To All Authorized Lamborghini Dealers and Licensed Service Point  
From Customer Service Department  
Page 4  
Subject Interface for K Line Pull Up  
Group 140.9.75.00.05.InterfaceLineK.GB  
Date 19.04.2005

Interface for K Line Pull Up for the radio

All Gallardo Vehicle with Radio System (not suitable for vehicle with Nav/Sat)

Pic 5

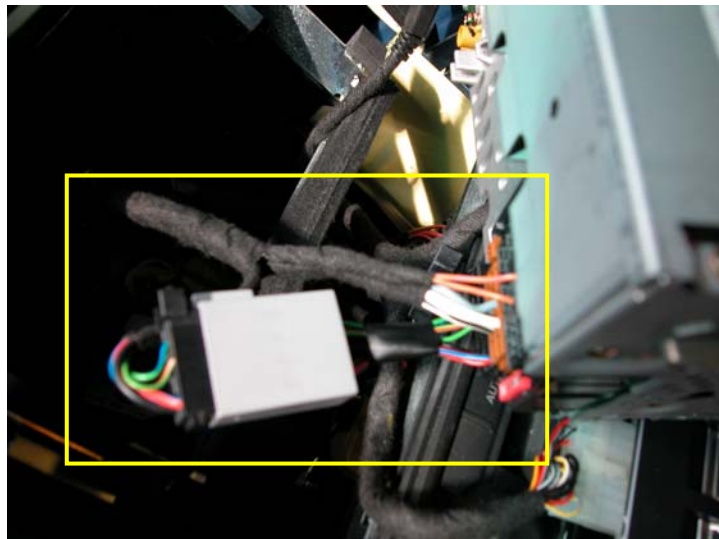
**1.5** Insert the Interface between the radio and the black connector 271 (Pic 5)
